Limerick City Greenway
(UL to NTP)

Stage 1 Road Safety Audit

Document Ref: P20100-PMCE-XX-XX-RP-SA-3_0002

3.1 Trees and Vegetation near the Greenway

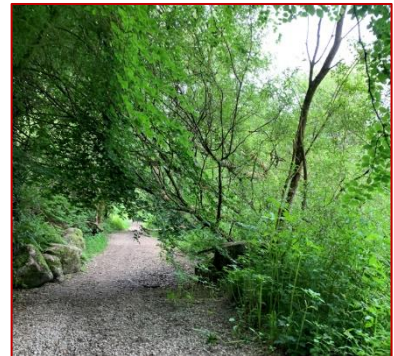
Summary: Low hanging tree canopies overhanging the shared path may conflict with users, leading to personal injury collisions.

Existing planting and low hanging tree canopies may conflict with pedestrians and cyclists using the new shared path. This may increase the risk of personal injury collisions.

Ensure low hanging tree canopies and overgrown vegetation is cleared from the new greenway, with at least 2.5m of clearance provided above the shared path.

3.2 Shared Use Path Transition

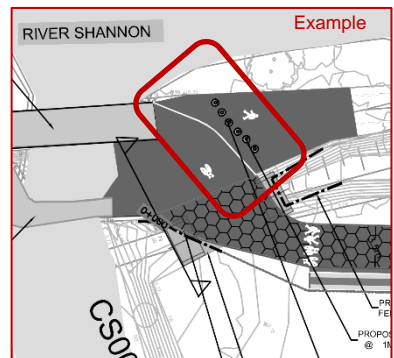
Summary: Risk of visually impaired pedestrians entering the shared path without due care and attention.

The proposed shared use greenway shares an interface with a pedestrian-only path at CH0+000, and several other locations throughout the proposed greenway. There is a risk that visually impaired pedestrians may enter the shared path without due care and attention, increasing the risk of pedestrian/cyclist collisions.

Provide tactile paving to advise visually impaired pedestrians that they are entering a shared path.

3.3 Inter-visibility

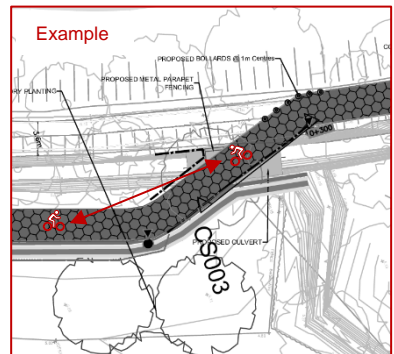
Summary: Risk of opposing cyclists being unable to see around abrupt changes in the horizontal alignment.

Changes in the greenway alignment may give rise to reduced inter-visibility between opposing cyclists, increasing the risk of head-on collisions where cyclists are unable to see an oncoming cyclist cycling around the bend. This could lead to personal injury collisions.

Ensure vegetation and/or bridge parapets do not obstruct inter-visibility at abrupt changes in the horizontal alignment. If necessary, provide additional widening at bends in the alignment to create greater separation between opposing cyclists/pedestrians, and improved visibility.

3.4 Transitions between Different User Facilities

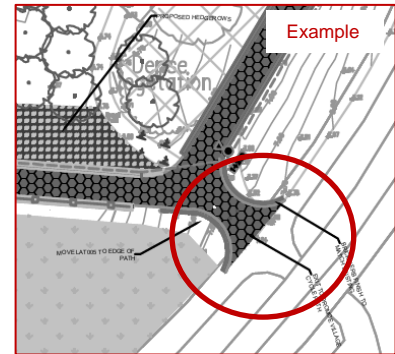
Summary: Visually impaired pedestrians may not be aware that they are moving between different user facilities (e.g. pedestrian-only to shared paths).

The shared path transitions to a pedestrian-only, or segregated, path at several locations along the route. There is a risk that visually impaired pedestrians may not be aware of the shared path when entering from these locations. This may increase the risk of pedestrian/cyclist collisions.

Ensure tactile paving and signage is provided to advise users of the transition from one facility to another.

3.5 Tactile Paving Depth

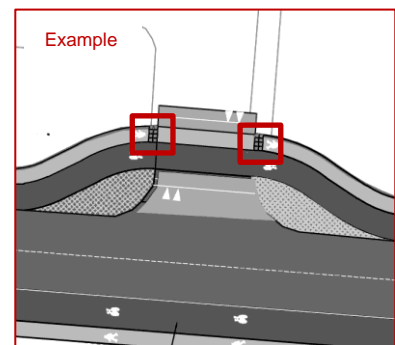
Summary: Visually impaired pedestrians may step over tactile paving at in-line crossings.

The depth of tactile paving at in-line crossings may be insufficient, so may increase the risk of visually impaired pedestrians stepping over the tactile paving and entering the carriageway without due care and attention, resulting in vehicle/pedestrian collisions.

Ensure the depth of tactile paving at in-line crossings is at least 1.2m across the full width of the crossing.

3.6 Public Lighting

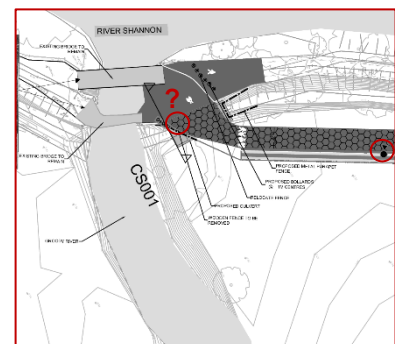
Summary: The absence of public lighting may create dark spots within the greenway, reducing visibility between greenway users.

Public lighting is not indicated at the junction between the proposed greenway, the pedestrian-only footpath, and the two existing bridges at the western extent of the scheme. The absence of lighting at the start/end of the greenway may create dark spots that results in reduced inter-visibility between users at a busy junction on the greenway, increasing the risk of pedestrian/cyclist collisions.

An additional lighting column should be provided near CH0+000.

3.7 Informal Cycle Parking

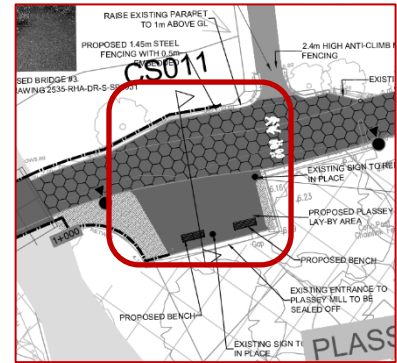
Summary: Informal cycle parking at lay-by areas may increase the risk of trips and falls.

Cyclists on the greenway may wish to stop at lay-bys to use the benches provided. The absence of cycle parking may lead to informal parking, where bicycles are left on the greenway, or beside the benches. This may increase the risk of trips and falls, leading to personal injury.

Cycle stands should be provided near lay-bys, and located strategically at areas where cyclists may wish to stop for short periods of time.

3.8 Transition between Different Surfaces

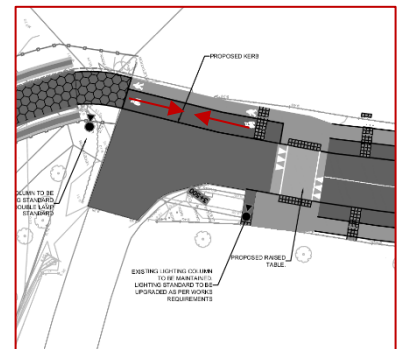
Summary: Risk of head-on collisions where opposing cyclists are directed to use the same cycle path.

The shared use section of the greenway transitions to a two-way segregated pedestrian/cycleway at CH3+500. It is not clear where southbound cyclists will go when they exit the shared use greenway, as the facility ties-in to the northbound segregated facility. This may increase the risk of cyclist confusion and head-on collisions where north and southbound cyclists attempt to share the same section of segregated cycleway.

This section of segregated cycleway/footway should be replaced with a shared use facility up to the proposed raised table at CH3+515. Wayfinding signage should be provided at the raised table to direct northbound cyclists onto the eastern side of the carriageway before entering the greenway.

3.9 Inter-visibility at Skewed Crossing

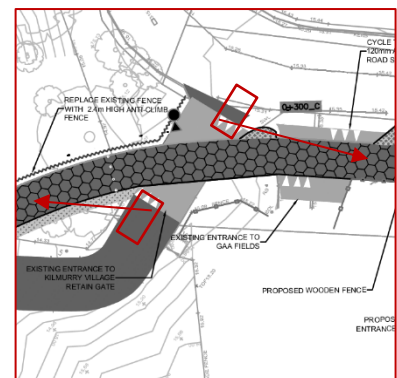
Summary: Drivers may be unable to clearly see approaching cyclists, who may be behind their field of view.

The proposed greenway crosses the existing access to Kilmurry Village at a skewed angle. This may limit a driver's visibility to an approaching cyclist from the left, who may be outside a driver's field of view, increasing the risk of vehicle/cyclist collisions.

The proposed greenway should cross the access at 90-degrees, supporting improved inter-visibility.

3.10 Pedestrian Desire Lines

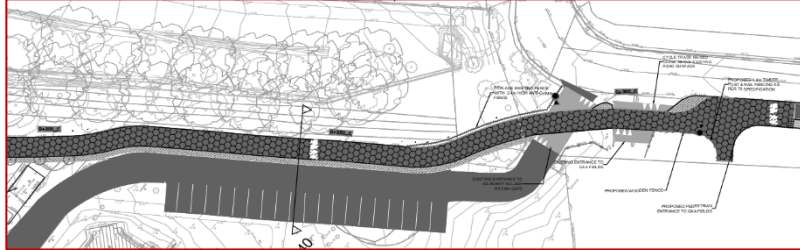
Summary: The absence of formal crossing points between existing footways and the new greenway may increase the risk of trips and falls or prevent mobility impaired users from accessing the new facility.

It is unclear if existing footways within Kilmurray Village and the GAA lands will be formally connected to the proposed greenway. It is likely that the new facility will attract a high number of pedestrians and cyclists from these areas, particularly given the high student population in this area. The absence of formal crossings or connectivity may increase the risk of trips and falls, or prevent mobility impaired users from accessing the new greenway.

Provide formal connection points for pedestrians and cyclists.

3.11 Crossing Type

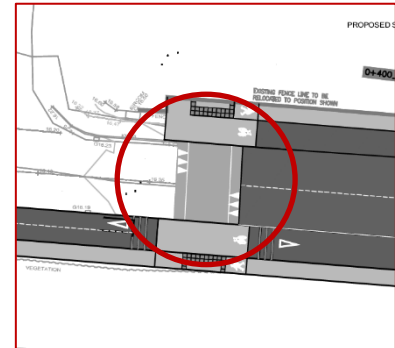
Summary: Crossing type may be insufficient for the type and volume of pedestrians/cyclists using the crossing.

The type of crossing proposed at CH0+375 is not indicated. There may be a risk of vehicle/cyclist collisions should the type of crossing used at this location be incapable of accommodating the volume of pedestrians and cyclists using the crossing.

Undertake an assessment to confirm that the crossing type is sufficient for the volume and composition of users at this crossing. If necessary, change the crossing type to ensure the crossing sufficiently caters for the number and type of users crossing at this location.

3.12 Tactile Paving

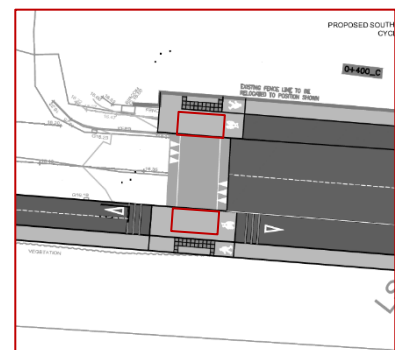
Summary: Pedestrians may continue into carriageway without due care and attention, leading to vehicle/pedestrian collisions.

The proposed arrangement may lead to visually impaired pedestrians crossing the short section of shared surface and continuing into the carriageway without due care and attention. Drivers, believing pedestrians would stop at the kerb edge before crossing, may be unprepared for a pedestrian to continue into the carriageway, increasing the risk of vehicle/pedestrian collisions.

The cycle facility should transition to a shared footway, with a conventional tactile paving arrangement adopted at the raised table crossing.

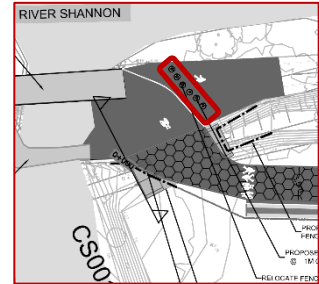
4.1 Bollards at 1m centres are indicated at the pedestrian path near CH0+000, and throughout the greenway. It is unclear if this will provide sufficient width for mobility impaired users (e.g. wheelchair users) to move between the pedestrian-only path and the shared used greenway. See NTA Guidance on 'Access Control of Active Travel Facilities' or seek guidance from the National Disability Authority.

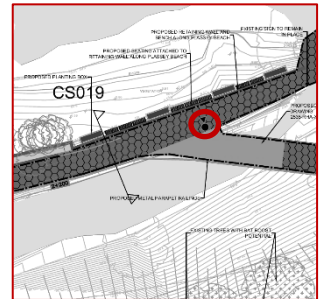
4.2 A public lighting column is indicated at CH2+225 and appears to be in the middle of the greenway, so may obstruct users. This is assumed to be a CAD error but should be relocated.

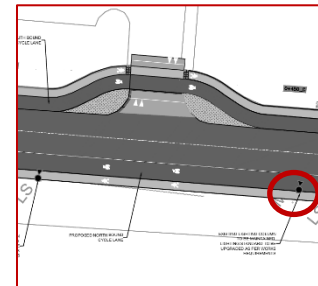
4.8 Public lighting column indicated straddling the footpath and cycle track. This is assumed to be a CAD error, but should be relocated.
